## **ALERT SERVICE BULLETIN**

**407-21-125**

**MODEL AFFECTED:** 407

**SUBJECT:** COLLECTIVE PITCH TRANSDUCER 412-074-101-107, INTRODUCTION OF.

**Figure 1 – Collective Pitch Transducer (CPT) Installation**

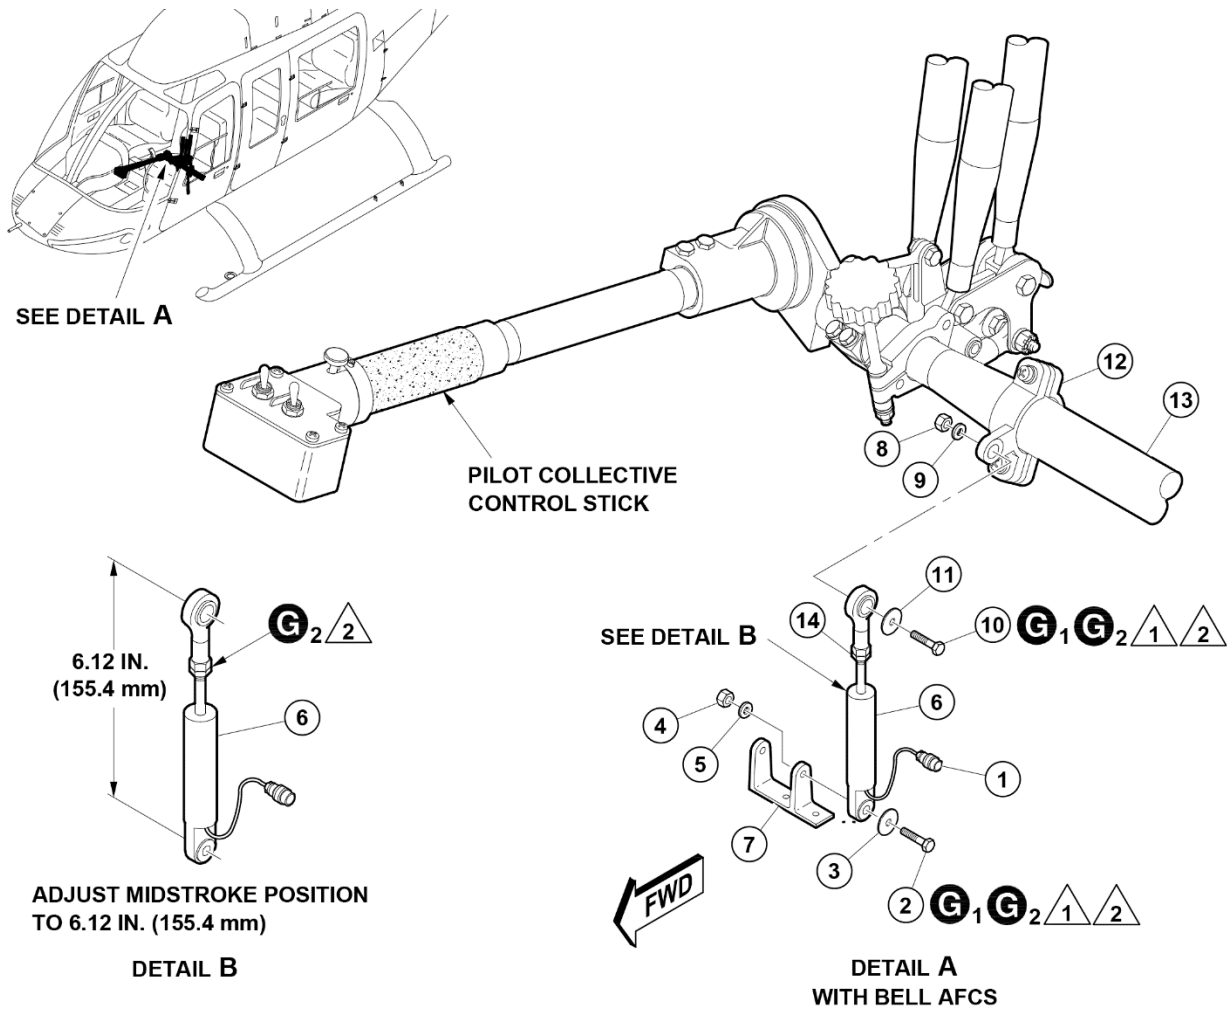
Bell has been made aware, and has been investigating, a condition where engine parameter oscillations and FADEC faults can occur during flight operations of the 407GX<sub>i</sub> variant of the model 407. To correct the possibility of these occurrences, Bell has redesigned the collective pitch transducer assembly. This Alert Service Bulletin (ASB) provides instructions to replace the 412-074-101-103 transducer by the new 412-074-101-107 transducer on all affected helicopters.

7. Install 412-074-101-107 transducer as follows (Figure 1):

- a. Loosen the nut (14).
- b. Adjust the collective pitch transducer (4R1) (6), as applicable, to obtain a 6.12 inch (155.4 mm) dimension between the centers of the grounded bearing and adjustable rod end bearing with the collective pitch transducer movable rod at the mid stroke position (Figure 1, Detail B).
- c. Tighten the nut (14).
- d. Make sure the clamp assembly (12) has not moved and is not loose on the collective jackshaft (13). If the clamp assembly is loose or has moved, position the clamp assembly ([DMC-407-A-76-05-06-00A-276A-A](#)).
- e. Position the collective stick in the full down position.
- f. Position the collective pitch transducer (4R1) (6), as applicable, between the support (7) and the clamp assembly (12).

- g. Apply corrosion preventative compound (C-104) to shank of bolt (2) (Figure 1, Note 1). Install the spacer (3) and the bolt (2) through the support (7) and the collective pitch transducer (4R1) (6), as applicable.
- h. Install the washer (5) and the nut (4) on the bolt (2). Tighten the nut.

- i. Before you install the collective pitch transducer (4R1) (6), as applicable, to the clamp assembly (12), make sure the collective pitch transducer rod end will fit the clamp assembly mounting hole position with the collective full up and the collective full down without causing restriction to collective travel or damage to the collective pitch transducer.

- j. Apply corrosion preventative compound (C-104) to shank of bolt (10) (Figure 1, Note 1). Install the spacer (11) and the bolt (10) through the collective pitch transducer (4R1) (6), as applicable, and the clamp assembly (12).
- k. Install the washer (9) and the nut (8). Tighten the nut.
- l. Apply corrosion preventative compound (C-101) to all bolt heads (2 and 10), washers (3, 5, 9, and 11), nuts (4 and 8), exposed threads of bolts (2 and 10), and nut (14) (Figure 1, Note 2).
- m. Remove protective caps and/or plugs from the collective pitch transducer electrical connector (4R1J1) (1).
- n. Connect the collective pitch transducer electrical connector (4R1J1) (1). Fold and secure the excess connector harness wiring with lacing cord or plastic cable ties.
